CERTIFICATE OF APPROPRIATENESS

**RE: Application Number 20-6983; 447 Henry; Cass-Henry Historic District
Project Scope: Rehabilitate Commercial Storefront Building**

RE: 447 Henry Street—William B. Ralston garage

Sheet
3A101

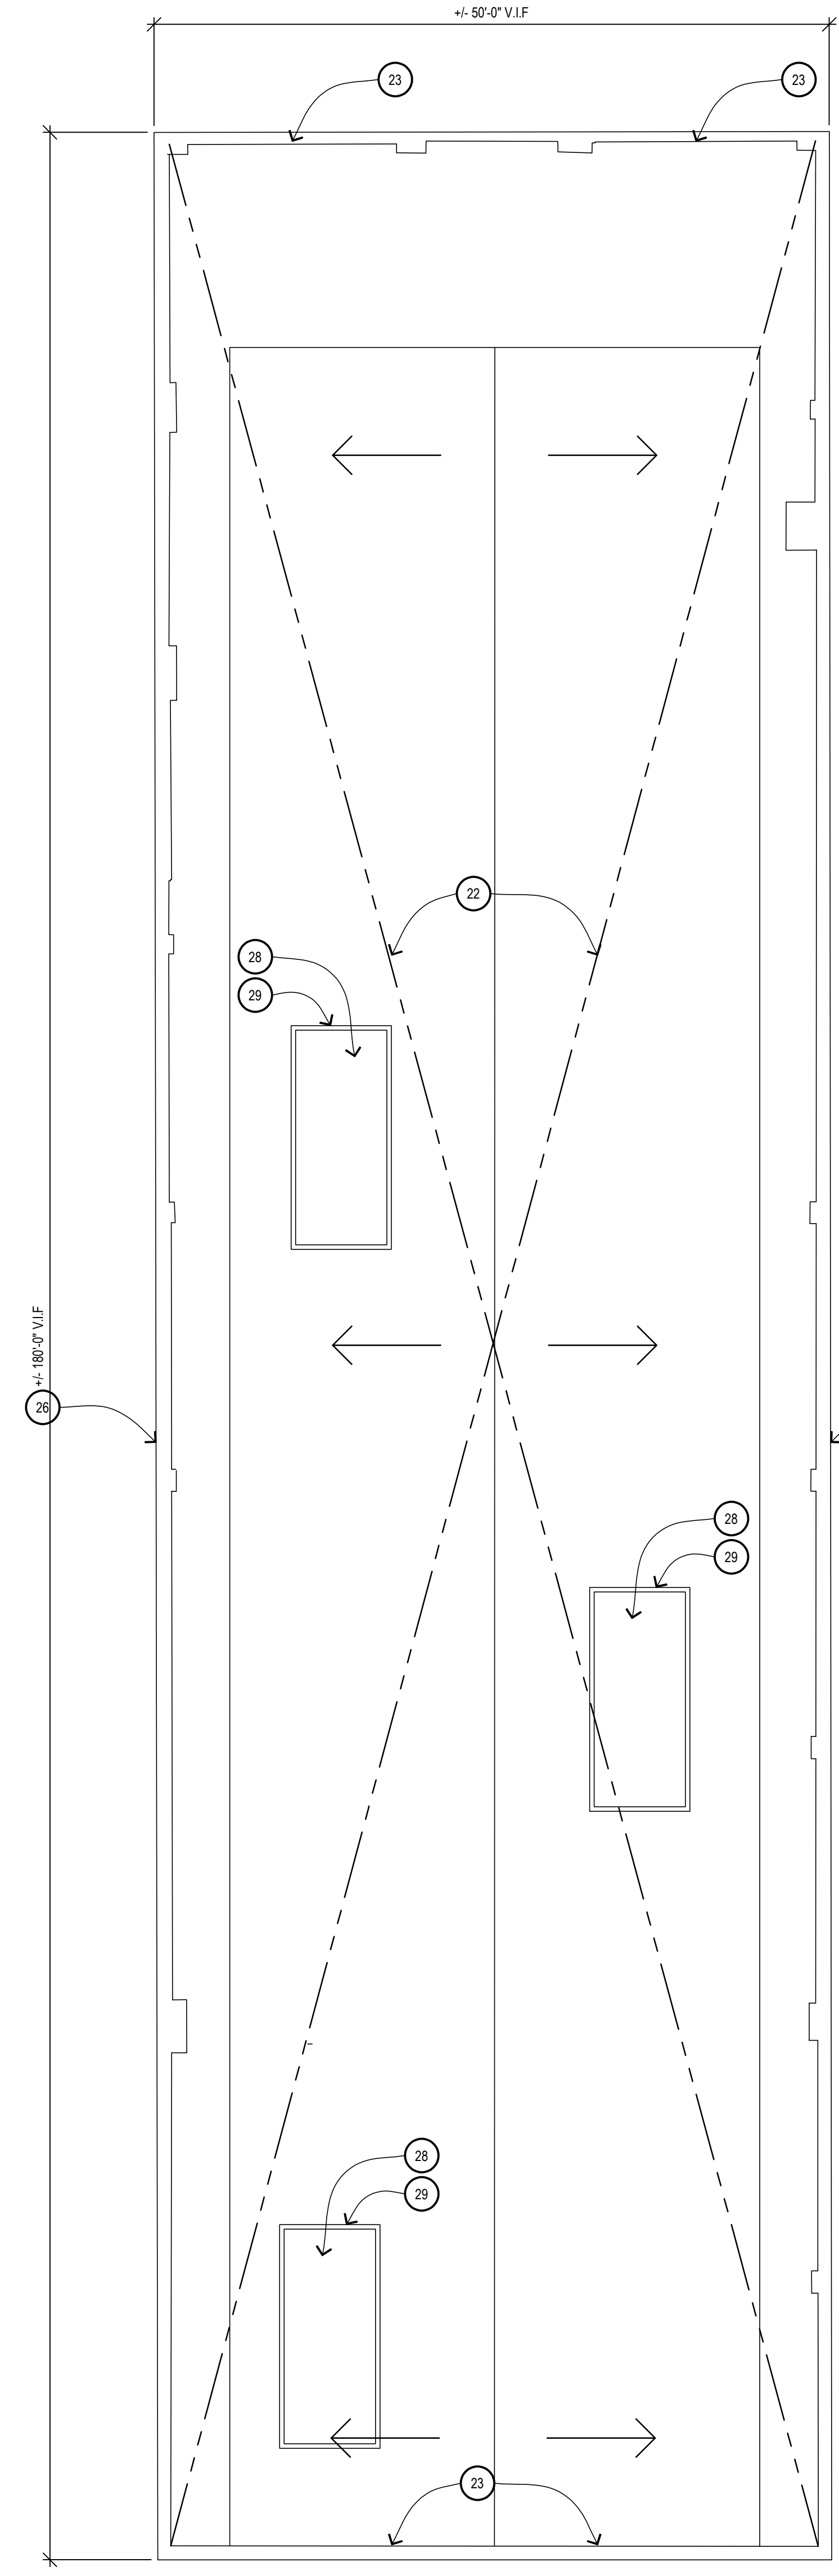
- *The center bay will incorporate a new entry door, cutting through the stone base [per 3A401 but not 3A401.1 or the floor plan, 3A101]*
- *All three bays will restore the glass transoms*

Sheet
3A401

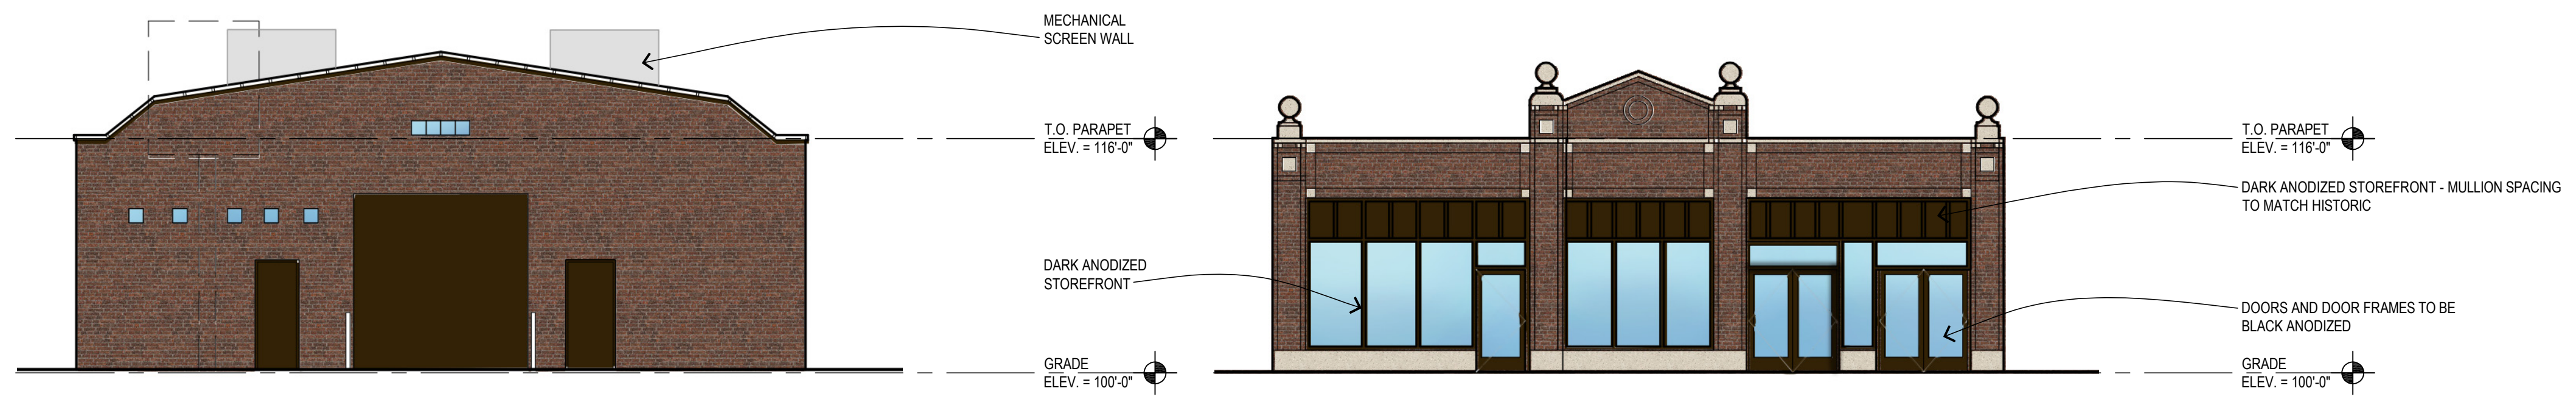
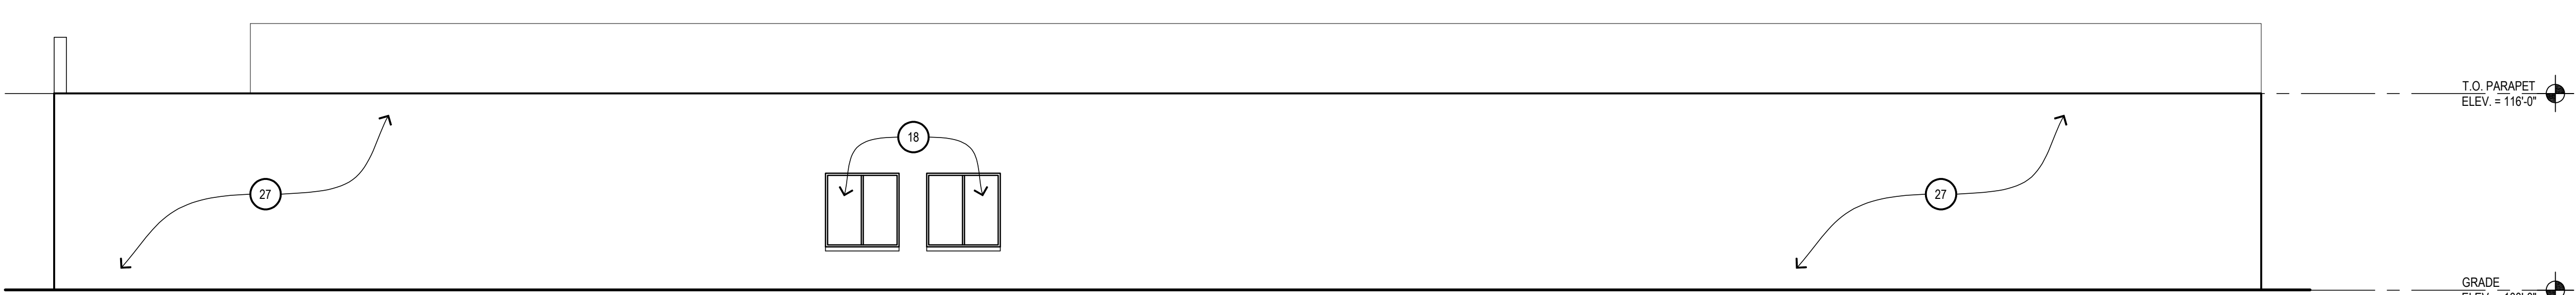
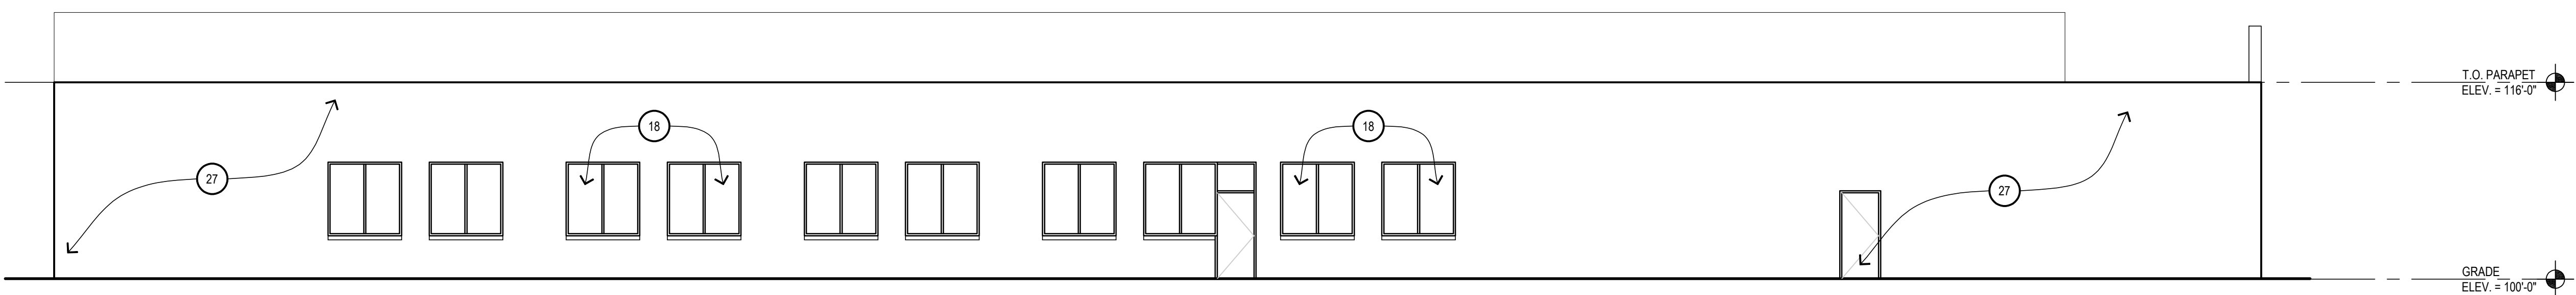
- *At east elevation, two new doors will be added to provide access to the “alley” which runs along the building. This “alley” will be paved. [paving material not provided; note also that this space appears to be part of the parcel on which Bretton Hall is built, not this building]*

- *At the east and west elevations, the existing windows [no existing windows are apparent, openings are blocked with CMU] will be replaced with new aluminum clad wood fixed windows*

- The design be modified to choose a different window type/configuration for the openings at the east and west elevations consistent with an industrial steel window style appropriate to the utilitarian historic context, subject to staff approval

Sheet
3A401.1

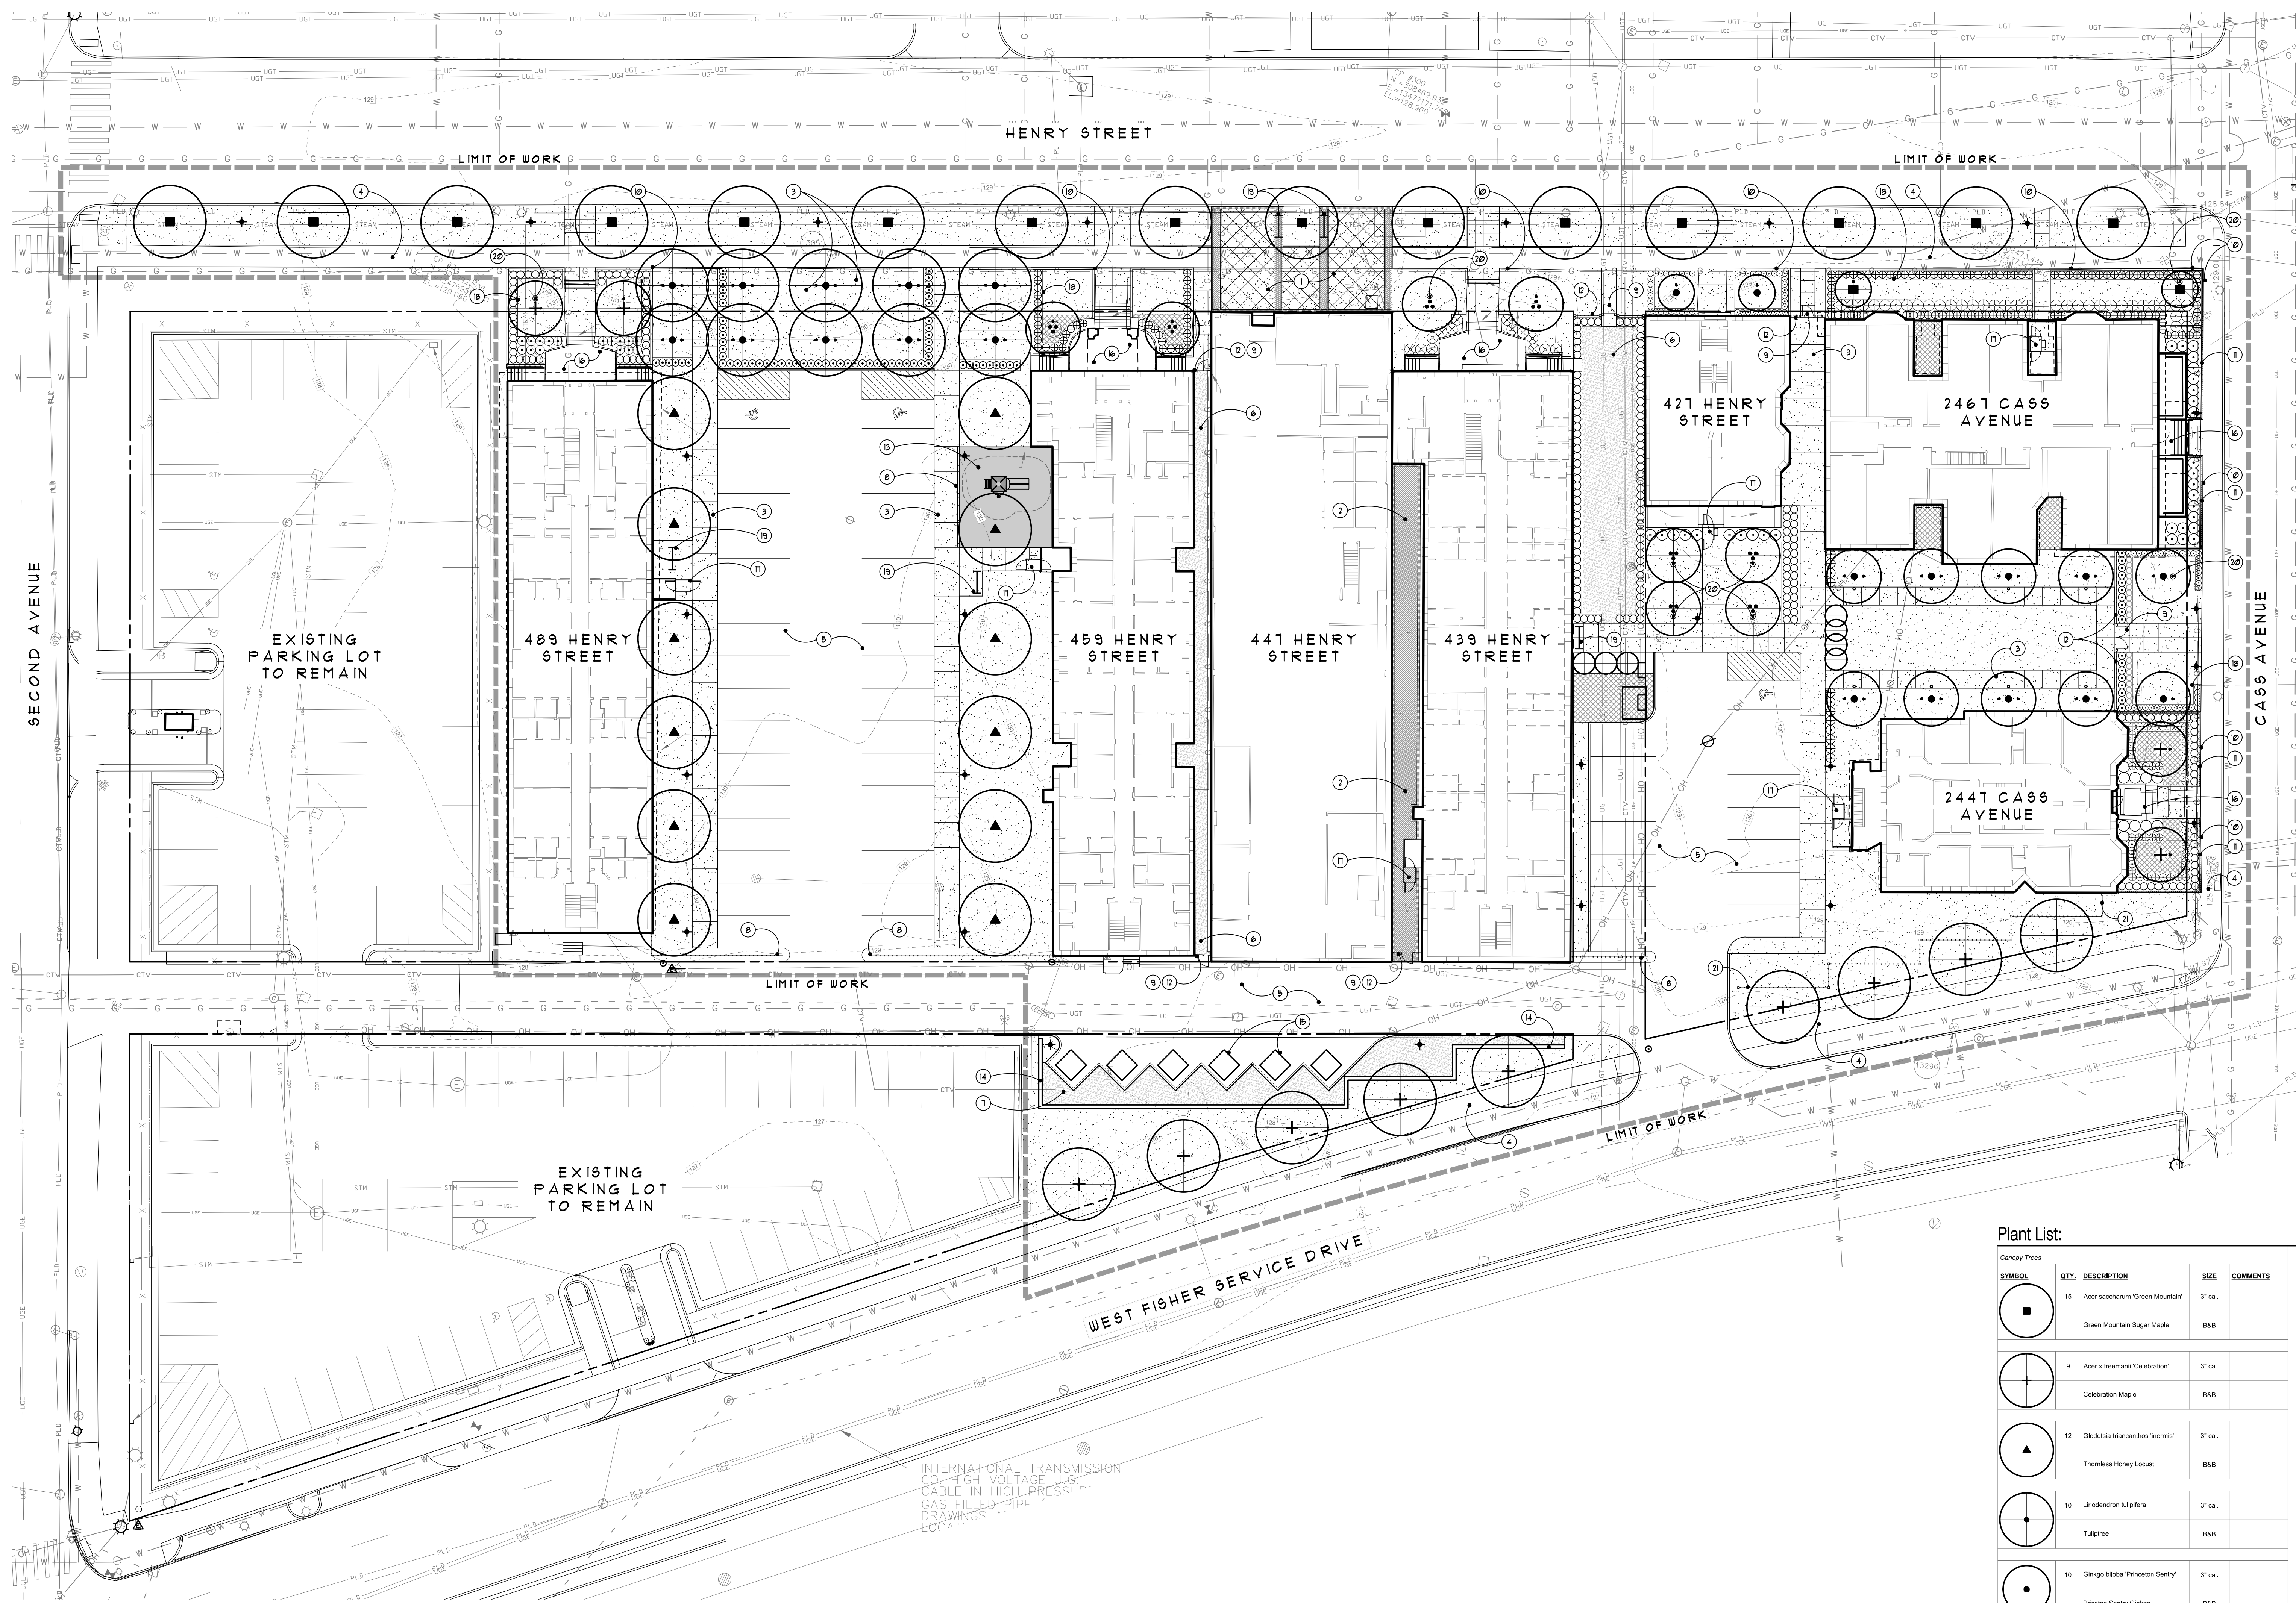
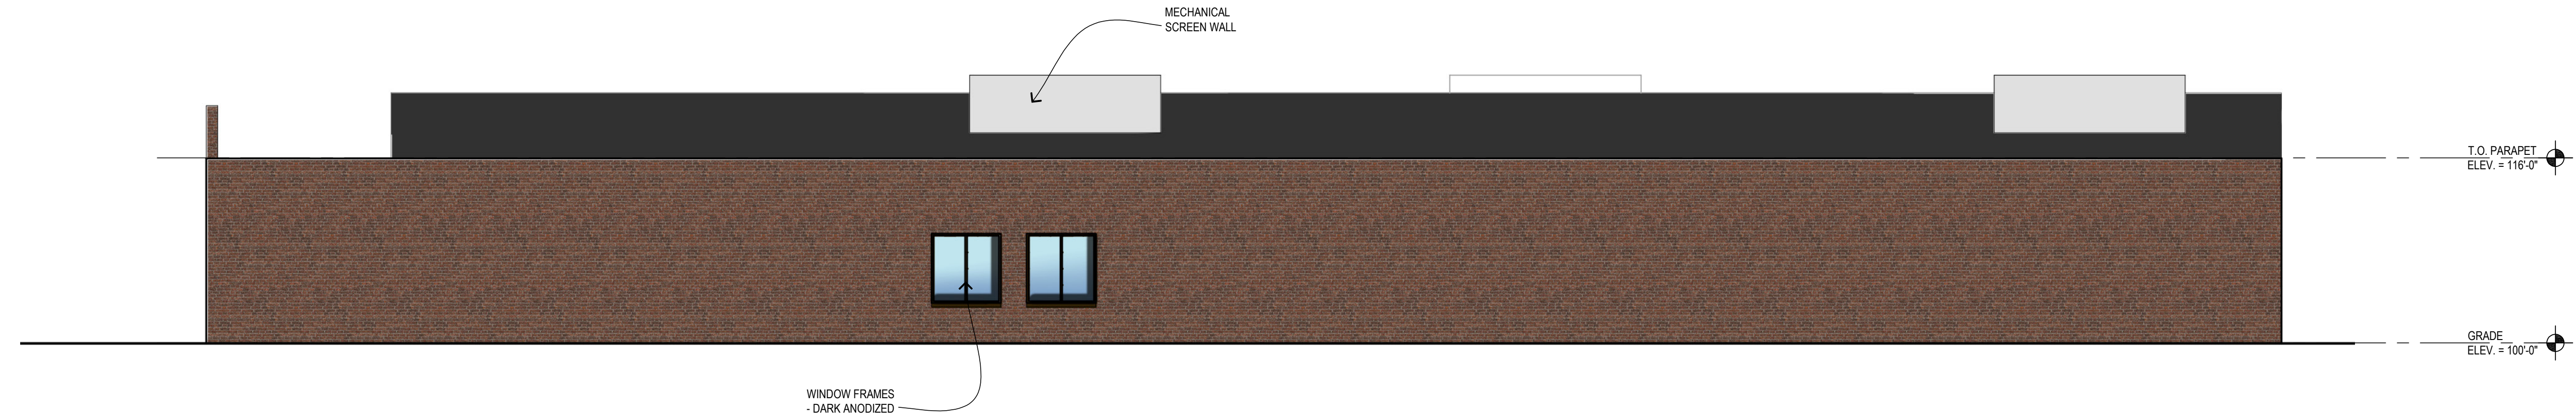
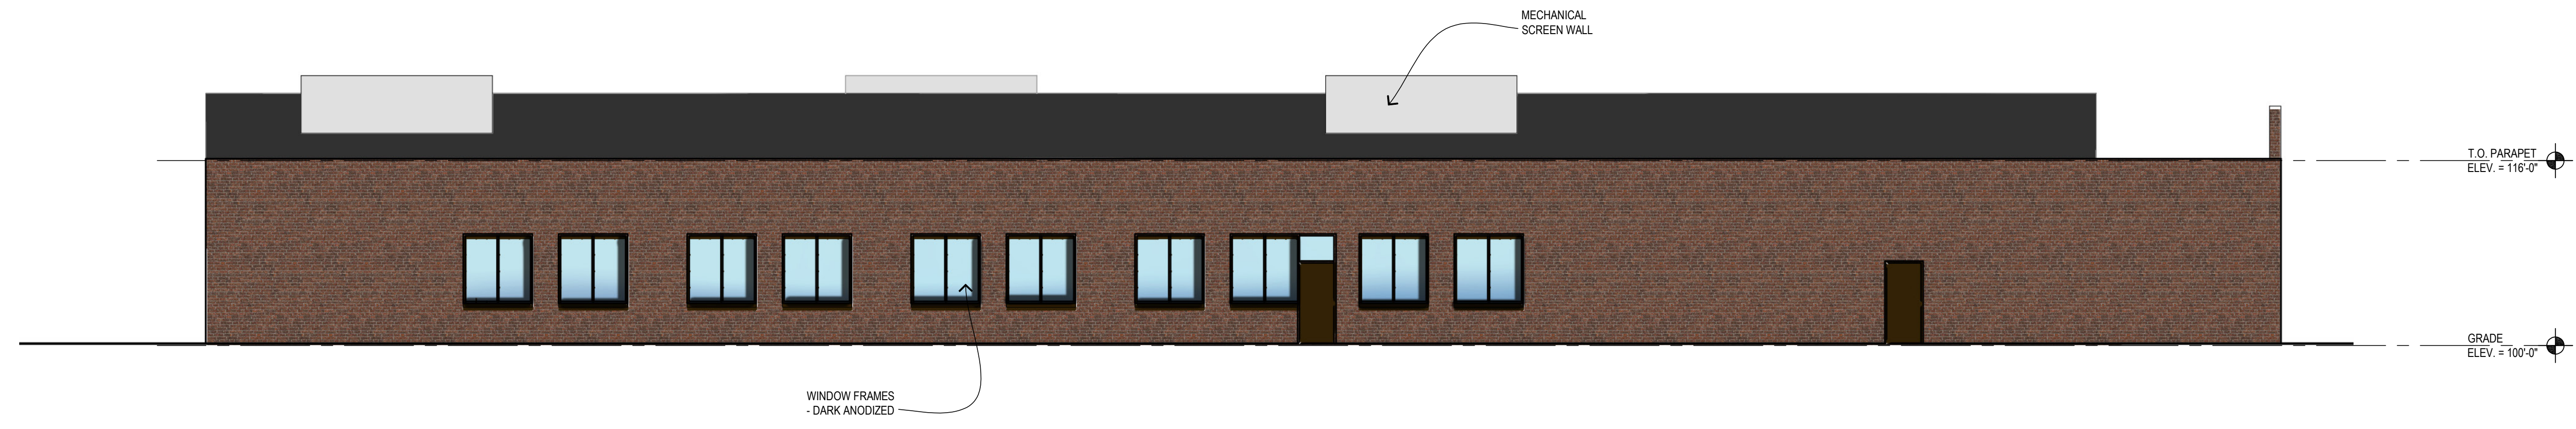
- The design be modified to prioritize the retention of historic materials across all three bays as revealed by further field investigation, to include the denticulated entablature at the westernmost bay, and that staff be given authority to review/approve a revision to the storefront design.
